To: Alan Schutz, Geophysical Survey Systems Inc
From: Andy Leimer
aleimer@fcc.gov
FCC Application Processing Branch

Re: FCC ID QF75100
Applicant: Geophysical Survey Systems, Inc.
Correspondence Reference Number: 23469
731 Confirmation Number: EA639721

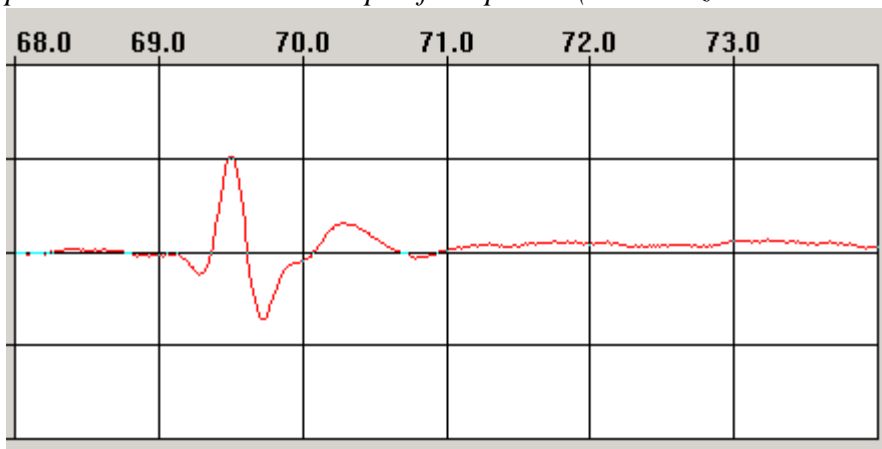
1) More information is needed on the 0.6 ns pulse. Is the pulse pseudo random (dithered) or is it periodic (You mentioned a maximum PRF of 200 kHz). Upload a plot of the pulse.

The pulse is not dithered, it is a fixed frequency. 200 KHz is the maximum allowable PRF because that is the frequency at which the emissions test was performed. The picture below shows the shape of the pulse. (The horizontal scale is in ns.)

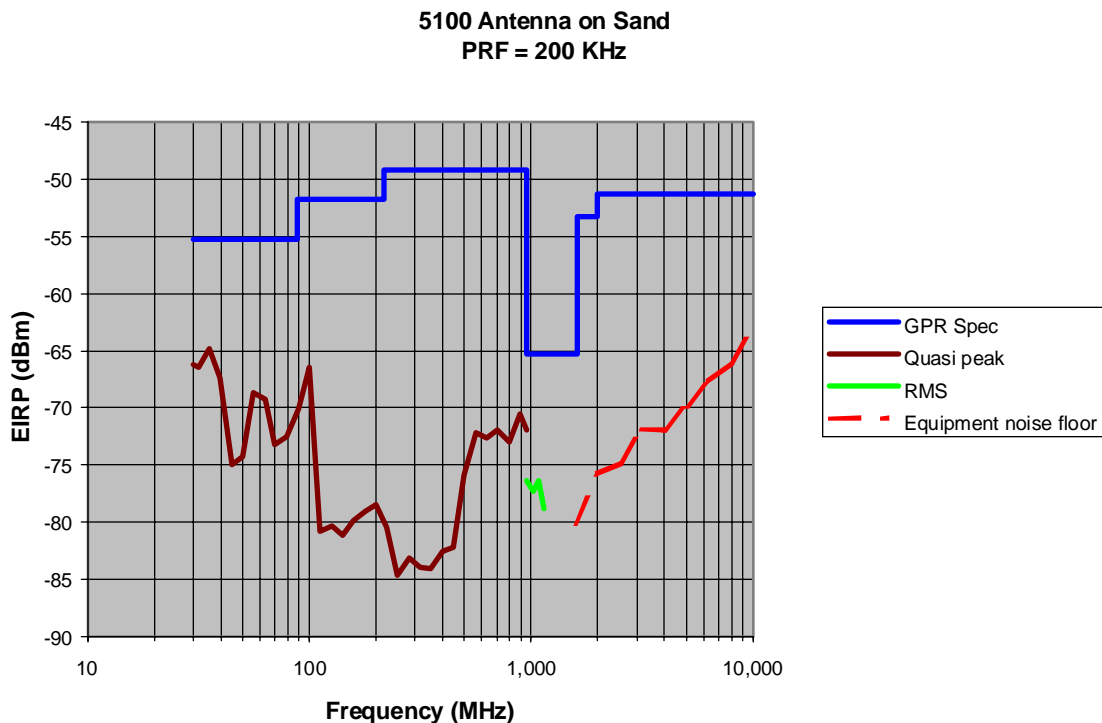
4) There is a procedure in the test report for the -10 dB points but no data or plots. Upload a spectrum plot and data for the -10 dB points. I suggest a field strength measurement for these points to account for non-linearities across the band that would be on the spectrum plot (ie: antenna and amplifier is not equal across the band).

From the plot below, the peak is shown at 35.45 MHz. The lower -10 dB point is below 30 MHz, probably about 20 MHz. The upper -10 dB point is just over 50 MHz. All data has already been corrected for antenna, amplifier, cables, etc. The data tables are in the test report.
